Agenda
Village of Arlington Heights
Design Commission
Community Room, 3rd Floor

Arlington Heights Village Hall
33 S. Arlington Heights Road
Arlington Heights, IL 60005
February 27, 2018
6:30 PM

MINUTES OF
THE VILLAGE OF ARLINGTON HEIGHTS
DESIGN COMMISSION MEETING
HELD AT THE ARLINGTON HEIGHTS MUNICIPAL BUILDING
33 S. ARLINGTON HEIGHTS RD.
FEBRUARY 13, 2018

ALA
Job Number: 17329
Sheet Number: A202
File Name: 17329202

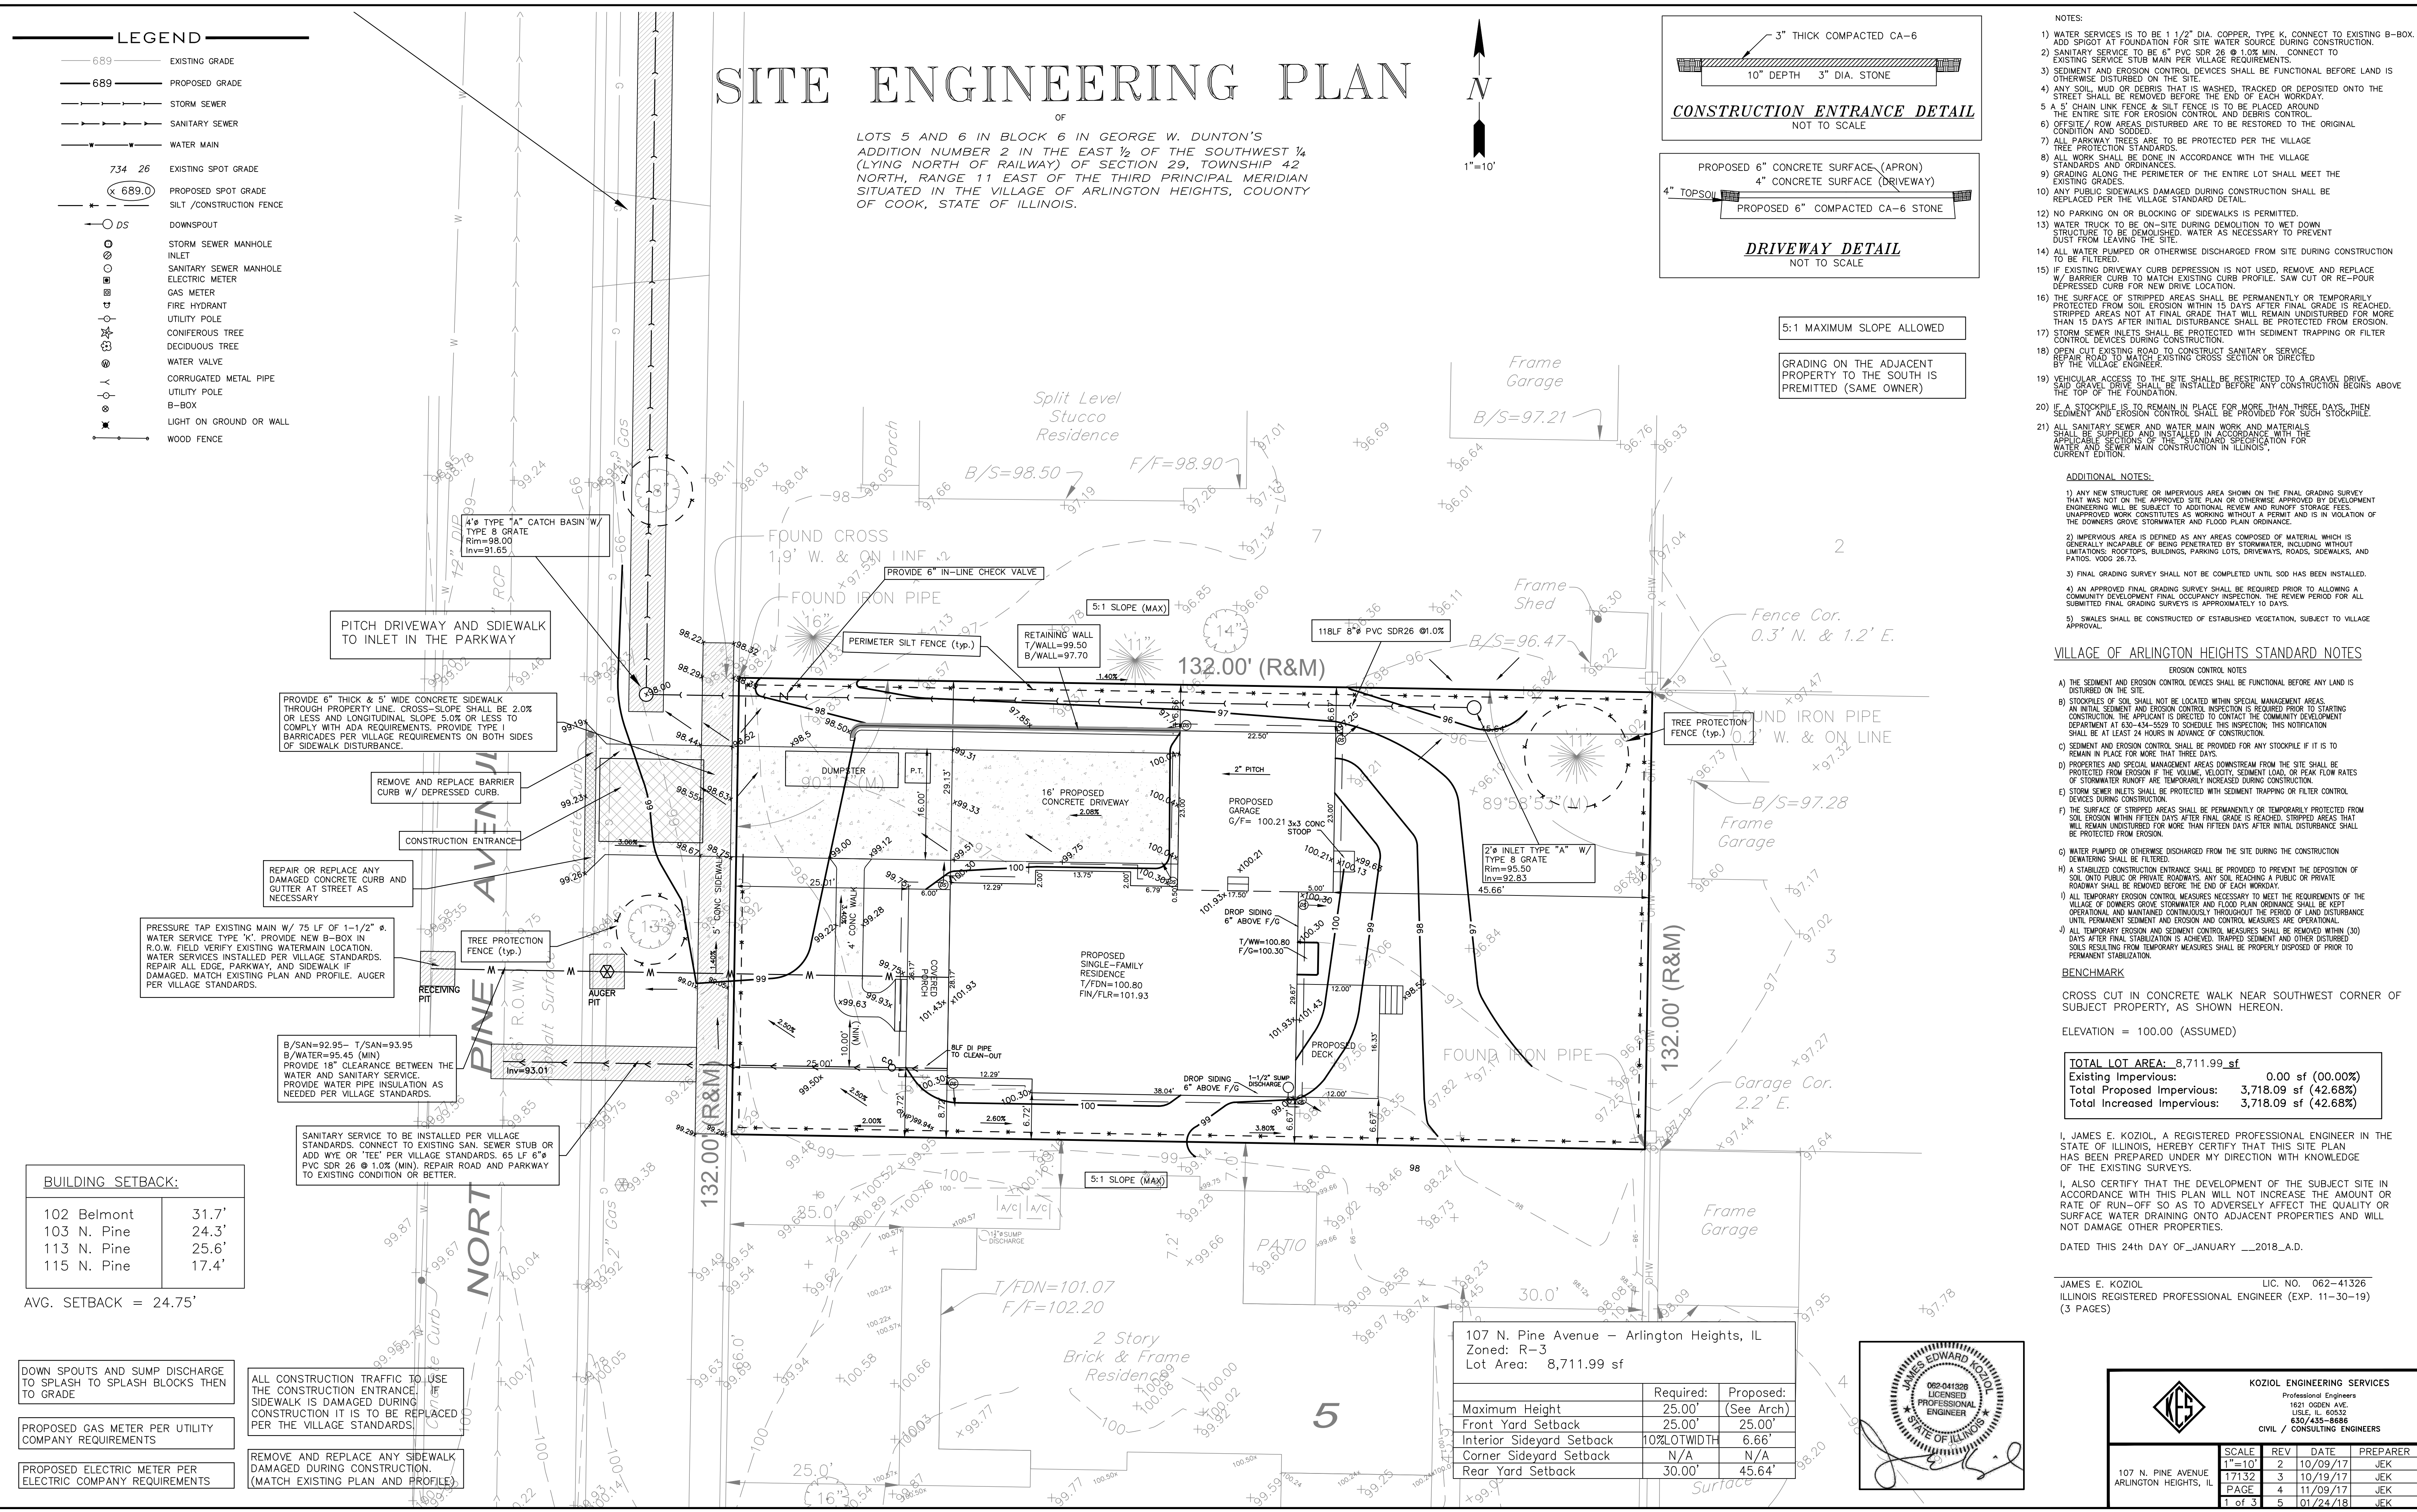
- It is recommended to add board and batten siding to the top part of the wall on the side of the garage, to be consistent with the rest of the design.
- It is recommended to add a window towards the front of the house on the right elevation to break up the blank wall. This could be achieved by rotating the coat closet layout creating a small corridor between the closet and powder room.
- The spacing of the windows under the porch looks off-center.
 - o It is recommended that the two office windows be pushed together and centered between the columns.
 - o It is recommended that the powder room window be changed to a smaller square window.

1. Add board and batten siding to the top part of the wall on the side of the garage.
2. Add a window towards the front of the house on the right elevation to break up the blank wall.

3. Push the two office windows together and center them between the porch columns.
4. Change the powder room window under the front porch to a smaller square window.
